Technical Service Bulletin							
Date Issued	Model Year(s) Affected		Model(s) Affected			TSB #	
02/11/2011	2010-2011		Diesel Pushers			384	
Brand						Type	
All <input type="checkbox"/>	American Star <input type="checkbox"/>	Mountain Aire <input checked="" type="checkbox"/>	All <input type="checkbox"/>	T T <input type="checkbox"/>			
Cypress <input type="checkbox"/>	Dutch Star <input checked="" type="checkbox"/>	Kountry Aire <input type="checkbox"/>	F W <input type="checkbox"/>	C A <input type="checkbox"/>			
Northern Star <input type="checkbox"/>	Kountry Star <input type="checkbox"/>	Essex <input checked="" type="checkbox"/>	D P <input checked="" type="checkbox"/>	D B <input type="checkbox"/>			
Scottsdale <input type="checkbox"/>	King Aire <input checked="" type="checkbox"/>	London Aire <input type="checkbox"/>					
All Star ME <input type="checkbox"/>	Ventana <input checked="" type="checkbox"/>	Bay Star <input type="checkbox"/>

CSB10-560-002

SUBJECT: Instrumentation – 5 in 1 Gauge

CONDITION: DEF Gauge reading incorrectly

5 In 1 GAUGE (REAR)
FIG. 2-2

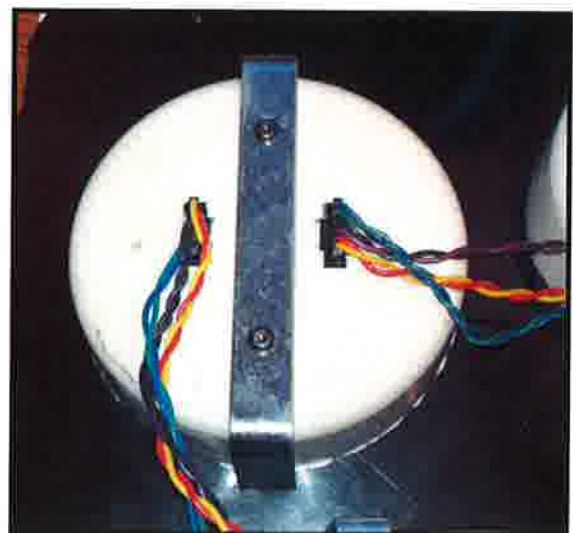
1. Remove gauge package. Disassembly dash if necessary to gain access to rear of gauge package.
2. Refer to FIG. 2-2. Disconnect black 6-way connector(s) (there may be 1 or 2 connectors attached, depending on the configuration) from the 5-in-1 gauge.
3. Refer to FIG. 2-2. Remove the 2 torx bolts that hold the c-clamp to the 5-in-1 gauge.
4. Refer to FIG. 2-1 & 2-2. Remove the 5-in-1 gauge. Properly discard gauge.
5. Install new 5-in-1 gauge. Reusing c-clamp and torx bolts, secure as needed.
6. Reconnect black 6-way connector. If applicable reconnect a second connector.
7. Reinstall dash board. Secure as needed.
